*Amended*  
**RESOLUTION NO. 2003-180**  
**ADOPTED BY THE SACRAMENTO CITY COUNCIL**  
**ON DATE OF APR 15 2003**

**RESOLUTION TO AMEND THE CENTRAL CITY COMMUNITY PLAN  
RELATING TO R STREET STREETScape SECTIONS BETWEEN 7<sup>TH</sup>  
AND 18th STREETS (M02-104)**

Figure 14a

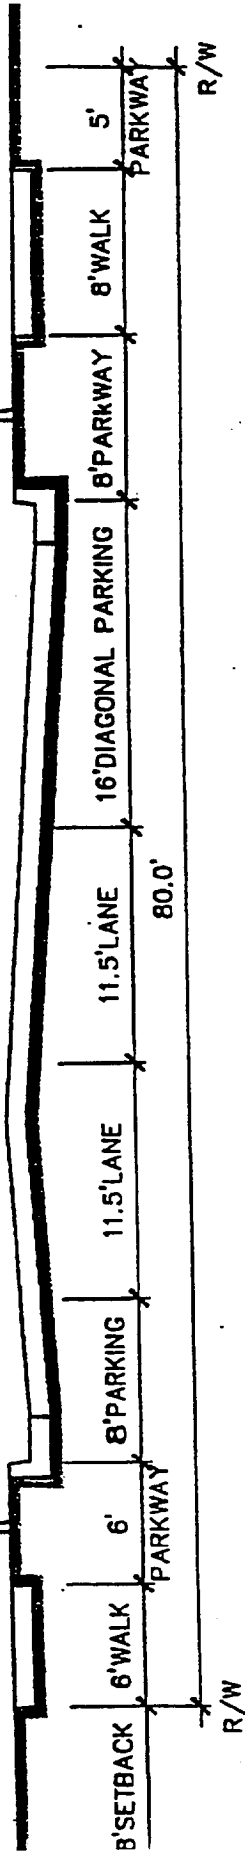
1. The City Council approves the Amended Figures 14 and 16 of the Central City Community Plan Relating to R Street Streetscape Sections between 7<sup>th</sup> and 18th Streets as indicated in Exhibits 1-4.
2. The City Council approves the Amendment Policy 11.1, Chapter X, of the Central City Community Plan "R Street Corridor Community Plan" section, as follows:

From 2<sup>nd</sup> to 18th Streets, an 80 foot right of way exists to accommodate the desired two way, two lane local street. From 3<sup>rd</sup> to 7<sup>th</sup> Streets the cross-sections will be those specified in Figures 14a and b. From 7<sup>th</sup> to 18th Streets typical cross-sections will be as indicated in Figure 14c. Alteration of this typical cross-section, to accommodate existing conditions, may be evaluated by staff on a case by case basis without need for a Community Plan Amendment. Certain minimum standards must be met by all proposed cross-sections unless existing conditions preclude compliance with the typical cross-section, as determined by the City: 1) Bulb-outs are generally required at all round corners unless determined otherwise by the City Traffic Engineer; 2) Applications for on-street diagonal parking shall be submitted to the Department of Public Works for review. Diagonal parking requests will be considered on a block-by-block basis. On-street diagonal parking must be approved by the City Council; 3) A minimum six foot wide sidewalk is required; 4) Street trees must be provided, with a minimum six foot wide planter, and; 5) Street lights must be provided."

R STREETSCAPE SECTION  
BETWEEN 3rd - 19th STREETS

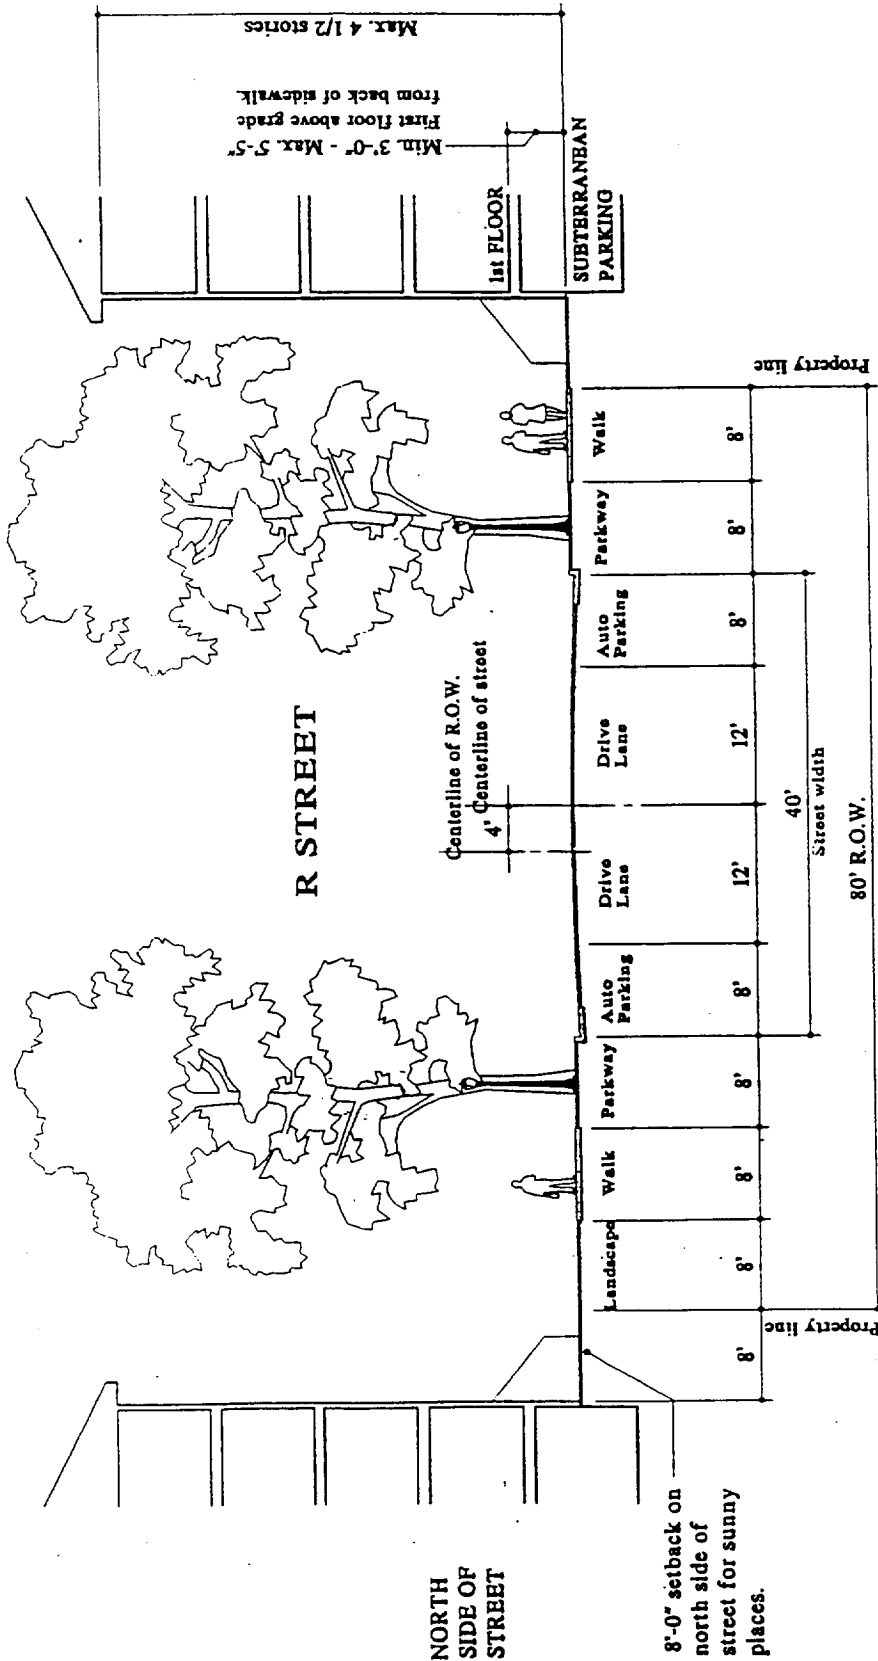
To be replaced by amended  
Cross-sections 14a-14c
